MERIDIAN STORAGE, LLC

SITE DEVELOPMENT PLAN

PPR2336

SITE MAP
0 20 50 100
SCALE: 1"=100'

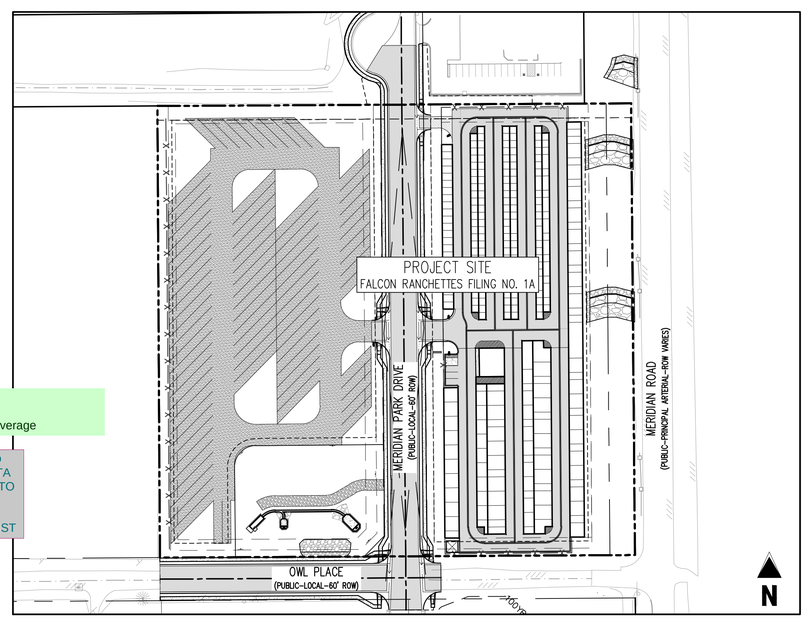
since there are two uses on site, we will require parking to be matched for both:
mini storage: 1/100 units (253 total) + 1/employee = 4
vehicle storage: 3 spaces
1 ADA space
= 8 spaces

INCLUDED REQUIRED PARKING, ORIGINAL UNIT COUNT WAS INCORRECT, ALSO REVISED PARKING COUNTS TO REFLECT THIS

SITE PLAN

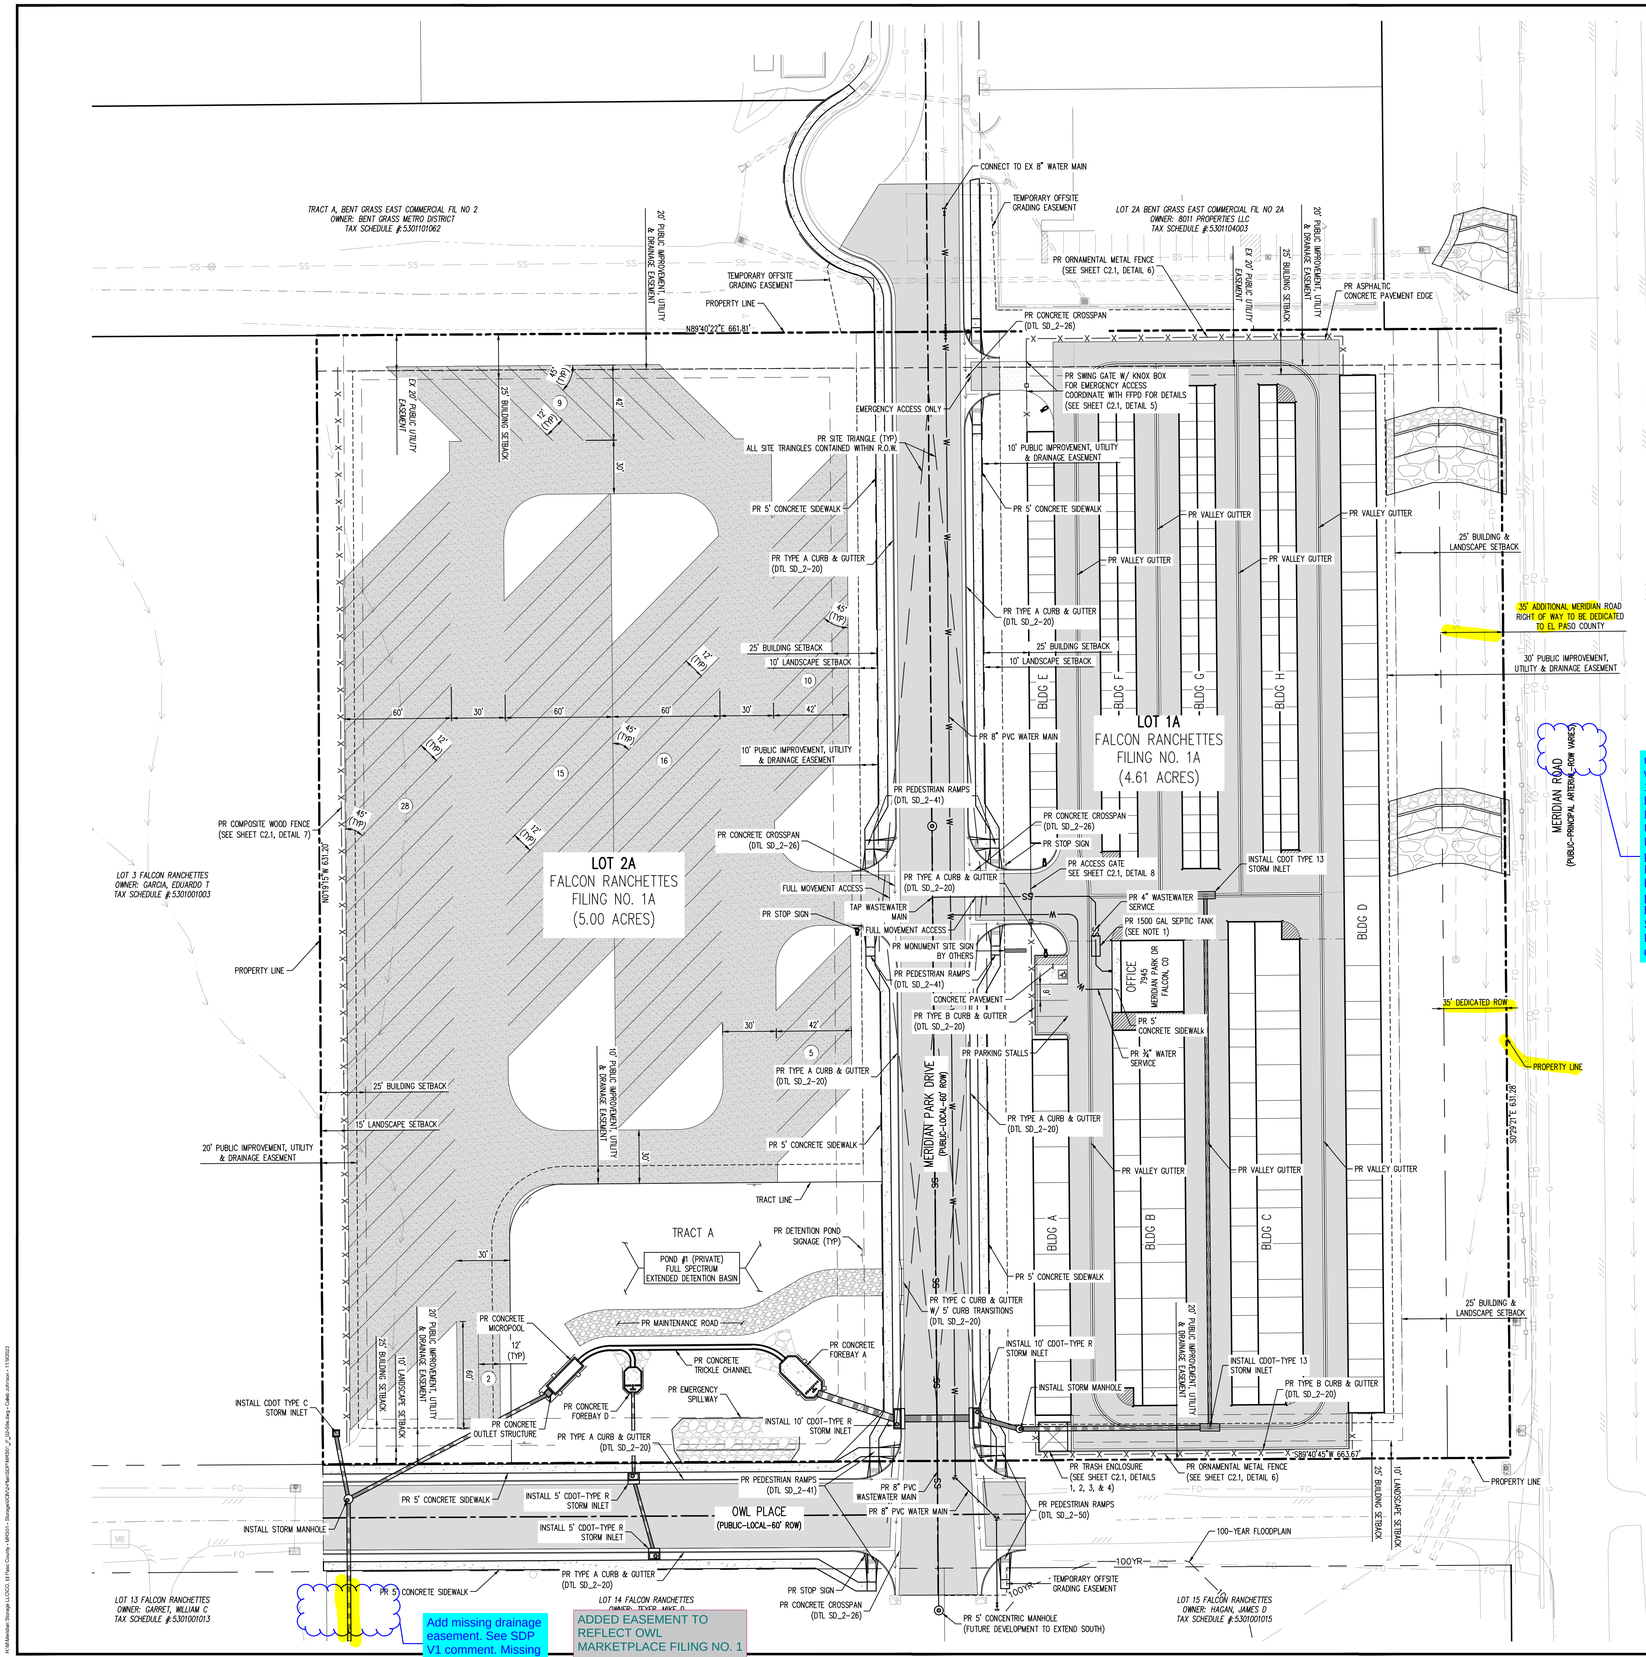
Please provide dimensions for signs, at least existing

Please depict :
-screening, where and dimensions
-traffic circulation of the properties
-layout of off street parking, loading, or other vehicular areas on the subject properties, if none, please specify
-location of floodplains, no build areas, if none then specify

ADDED DIMENSIONS IN THE CALLOUTS

REVISED COMMENT PER EMAIL COORDINATION WITH DANIEL TORRES. PLEASE CONTACT US WITH ANY QUESTIONS

ADDED ALL REQUESTED ITEMS AND ASSOCIATED NOTES THAT REFERENCE PARKING PLAN AND LANDSCAPE PLAN.
